# Access Compliance Report

## Public Rights-of-Way

### (Curb Ramps)

Intersection ID: 12527	Main Street: E_7TH_ST	Cross Street: N_DAVIDSON_ST	Location: E
ADA ID: 5C89E388442B	Ramp Type: PerpDiag	Initial Pass/Fail: Fail	Overall Compliance: No
Severity Score: 8.75			
Codes/Mitigation Info/Possible Solution		Field Measurements/Component Compliance

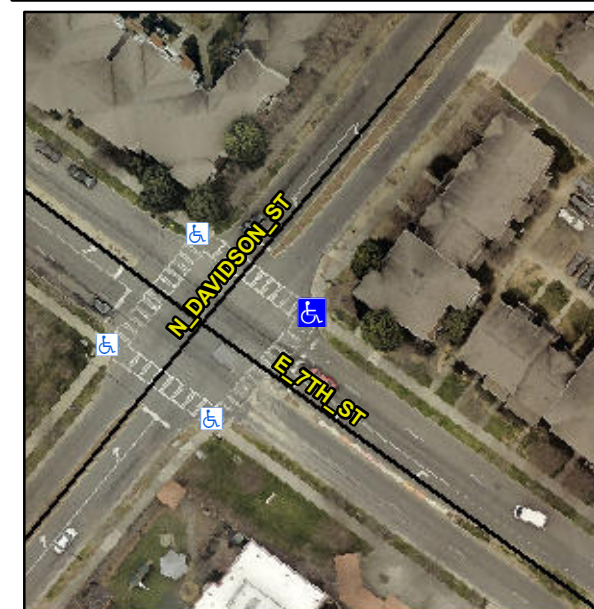
**R304.5.1**

**Remove & Replace Curb Ramp With Two New Directional Ramps or Equivalent.**
